Review of Engineering Servicing Report for LandCorp on Cockburn Central West

The report, as prepared by Pritchard Francis, Revision 1 (April 2013) refers. We can confirm that the report remains largely relevant with the exception of some minor amendments, which we now submit as addenda to the report. They are as follows:

Figure 4.1: Stage 1A

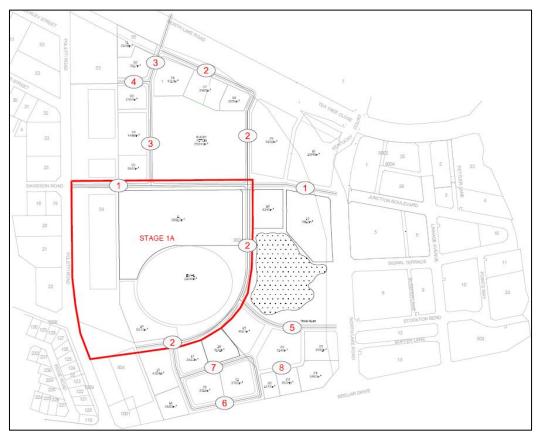
Stage 1A – Civil Works for Oval and Community Facilities

During Stage 1A, necessary earthworks will be carried out including stripping topsoil from these first stages of the site, and cut to fill necessary for the early stages of works such as the new football oval and the future recreation facilities areas. If required, the adjacent Western Power easement may be cut for use as fill.

This stage of works will include construction of a portion of Road 1 and Road 2, the associated drainage, extension of services to the site from existing infrastructure located North West of the site on North Lake Road, retaining walls and other works associated with development of the main oval and support precinct area. The immediately adjacent carparks within the Western Power easement may also be constructed. Further to this, some early drainage works and drainage management features may be constructed within the wetlands area, to be able to manage the initial drainage coming from the early stages.

Figure 4.2: Stage 1B

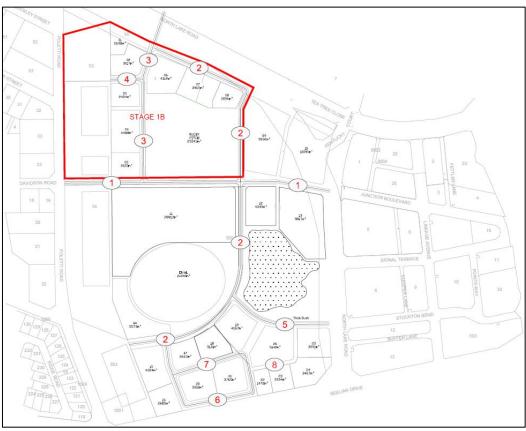
Stage 1B – Civil Works for North West precinct and playing fields

During Stage 1B, necessary earthworks will be undertaken including the filling operations required for the playing fields and the North Western lots. The adjacent parking areas within the Western Power easement may also be cut for use as fill and any excess fill may be stockpiled on the playing fields until the next stage begins.

This stage of works will also include civil works such as construction of Road 4, Road 3 and the balance of Road 2. It will also include stormwater drainage, sewer, water, power, gas, communication and infrastructure required to service the proposed areas and playing fields. Works will also include servicing for lots being released in this stage. There may also be a requirement to construct a sewer pump station at this stage of the development, at a low point, possibly adjacent to the wetland site, where sewer drainage is pumped to the Northwest corner of the site. This requirement will be determined during detailed design.

Figure 4.3: Stage 2

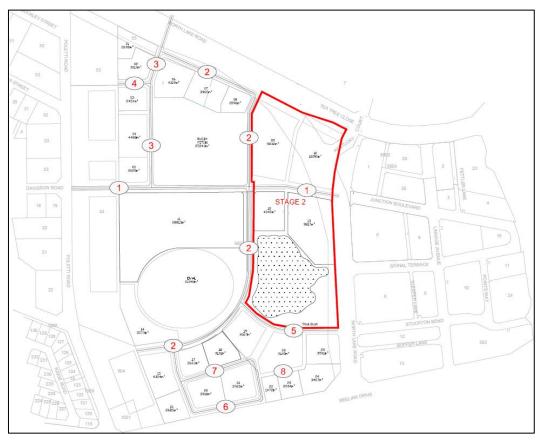
Stage 2 - Civil works for North East precinct

Completion of topsoil stripping and earthworks fill operations will be undertaken as required. Civil works including the construction of the balance of Road 1 as well as the intersection with Midgegooroo Avenue, the provision of water, sewer, stormwater drainage, retaining walls and authority services required to release these lots will be undertaken. The area within and immediately surrounding the wetland will be constructed and upgraded, including drainage management features, hard and soft landscaping, and any other requirements arising from environmental and local authority requirements, as per the Local Water Management Strategy.

Figure 4.4: Stage 3A & 3B

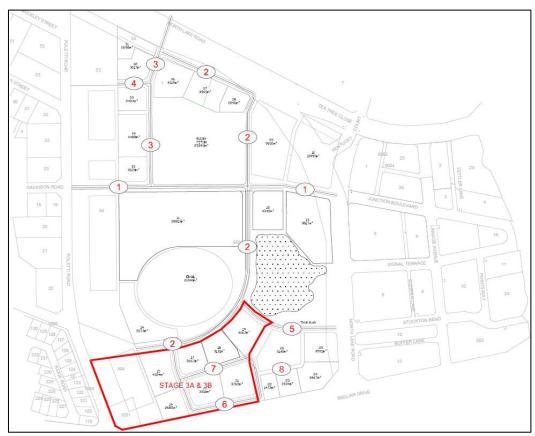
Stages 3A – 3C – Development Release – Vision Completion

This area may be undertaken in one operation or in smaller staged sections dependent upon lot demand; however it will entail the completion of earthworks as required, with a cut to fill operation from west to east. Civil works including the provision of water, sewer, stormwater drainage, retaining walls and authority services required to release these stages will be undertaken. This will also include the construction of Roads 6 and 7, laneway 8 as well as Road 5 and its intersection with Midgegooroo Avenue. Further to this the balance of any parking not already constructed within the Western Power easement will be finalised at this stage.
